In the Matter of
NEXTERA ENERGY SEABROOK, LLC
(Seabrook Station, Unit 1)

Docket No. 50-443-LA-2
ASLBP No. 17-953-02-LA-BD01

**PRE-FILED OPENING TESTIMONY OF VICTOR E. SAOUMA, PH.D
REGARDING SCIENTIFIC EVALUATION OF NEXTERA'S
AGING MANAGEMENT PROGRAM FOR ALKALI-SILICA REACTION
AT THE SEABROOK NUCLEAR POWER PLANT**

SUBMITTED ON BEHALF OF C-10 RESEARCH AND EDUCATION FUND

Figure 3 Boundary Conditions

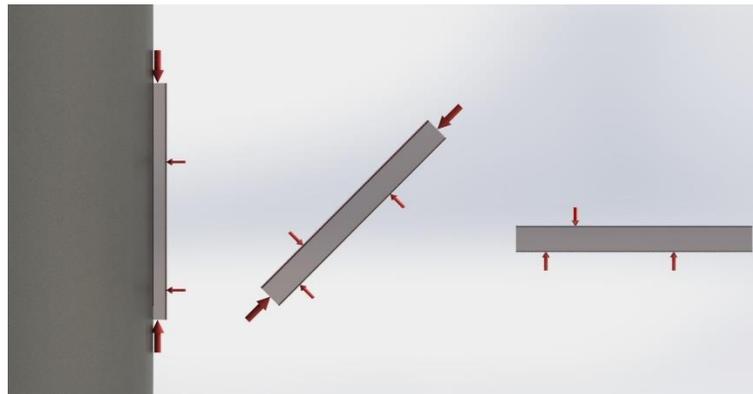
In a test, the model must be subjected to the same conditions (support, restraints and load) as the prototype (Seabrook). In this case, as shown by Figure 2:

- The FSEL tests modeled only the out of plane shear and not the in-plane. This can be visualized by holding a can in your hand and pushing in one direction. Along that direction the can must provide an out of plane shear resistance. But at 90 degrees, the can will be in in-plane shear mode. The later one was not tested. Out of plane results may not be directly applicable to in-plane. See Figure 3a.
- The beam (shown below in Figure 3b) was restrained from lateral expansion due to the adjacent concrete. This was accomplished by placing reinforcement as shown in Figure 7.
- The load has to mimic (to the extent possible) the lateral load caused by an earthquake. This is appropriately accomplished by the forces shown.

- However, the axial forces caused by the weight of the dome and the walls are not present in the beam. This pre-existing axial force has a strong influence on the shear response and will substantially negate the prestressing effect. Therefore:
 - The expansion in the vertical direction will be inhibited and redirected in the out of plane one where it has no impact on shear.
 - The magnitude of the ASR induced prestressing may be dwarfed by the pre-existing axial forces due to gravity load and hence cannot be relied upon.

a) Only out of plane shear (on the left) is tested. Impact of ASR on in-plane shear (on the right) is not assessed.

b) The beam is supposed to be representative of a segment of Seabrook. Hence, one can visualize the test as “peeling” away a beam out of it, and ensure that the beam will be subjected to the same loads as in Seabrook. In this case, one should also have an axial force (shown in the “rotating” beam), but by the time the beam is tested at FSEL the axial force is no longer present.

Tests were performed for out of plane shear, and they were indeed criticized because results were also applied to zone in-plane shear. This is best illustrated by Figure 3-a.

Figure 12 FHWA report by Fournier, B., Berube, M. A., Folliard, K. J., & Thomas, M. (2010).

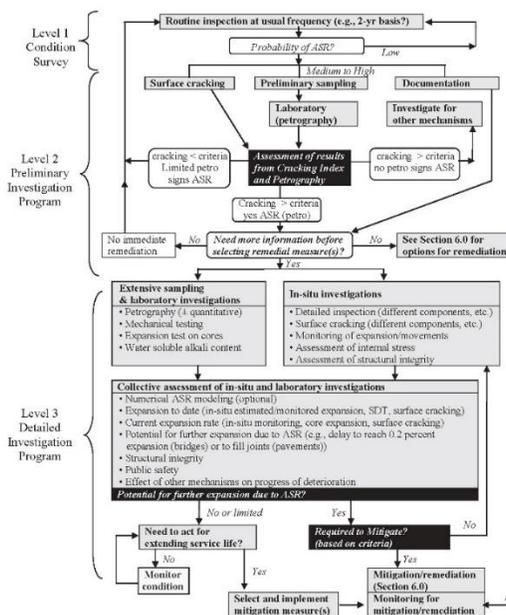
Furthermore, CCI has been justified by reference to a Federal highway administration report. However, inspection of Figure 12 of this FHWA report by Fournier, B., Berube, M. A., Folliard, K. J., & Thomas, M. (2010) in Sect. 2.2. indicates that CCI can only be used in conjunction with petrography for Level 2:

Based on the above reputable report, In the context of Seabrook, CCI should be used in conjunction with continuous/additional petrographic studies.

Figure 13 Progression of ASR and likelihood of being captured by CCI

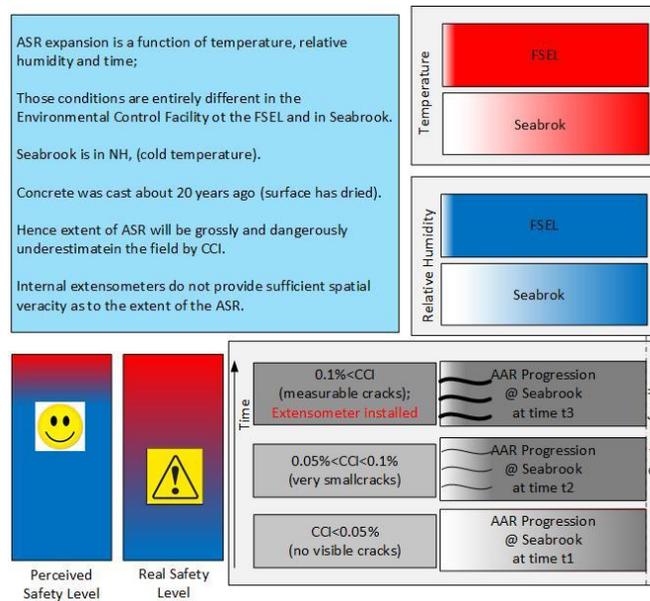
Hence, should cracking be noticeable (through the CCI), that would imply that the internal swelling (where the RH is higher than 80%) was so great that it affected the surface cracking. By the time extensometers are installed, it may already be too late, Figure 13.

Therefore, I conclude that as a monitoring measure, CCI must be ruled out completely.

Again, wrong. As previously illustrated, Figure 13 the crack index is a most unreliable indicator of ASR, and no serious researcher would rely on it.

Figure 16 Some ignored considerations in the analysis that may severely impact results

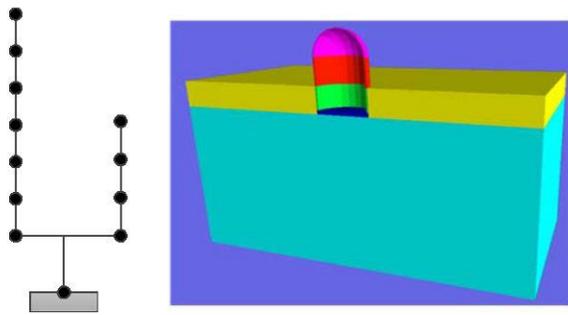
ASR was modeled in that portion of the concrete below grade as it is that portion most likely to have been in contact with water. Hence, one would have to assume that the base mat will also suffer from ASR. This will result in a “bubble” expansion with corresponding lift-off in the middle, whereas on the periphery the walls provide sufficient restraint,

14. **pg. 44** *Response spectra analysis was performed using a simplified "stick" model. For lateral analyses, the model was fully fixed below El. 0 ft. For vertical analyses, the model was fixed at the base at El. (-)30 ft.*

Again, the stick model is a model of the past when computers did not have sufficient capability to handle the time history analysis of a 3D model, Figure 16-b. The stick model is overly simplistic, as discussed in the quote below:

Figure 17 Not modeled impact of soil in the seismic analysis

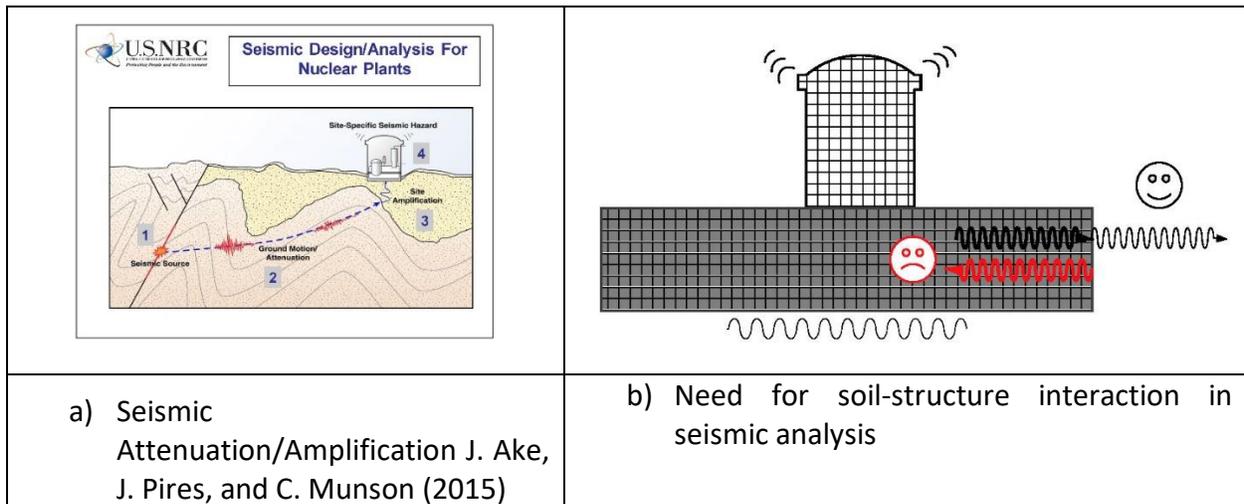
19. Impact of soil through proper deconvolution or soil structure interaction is not accounted for as required by ASCE 4-16 (2016),
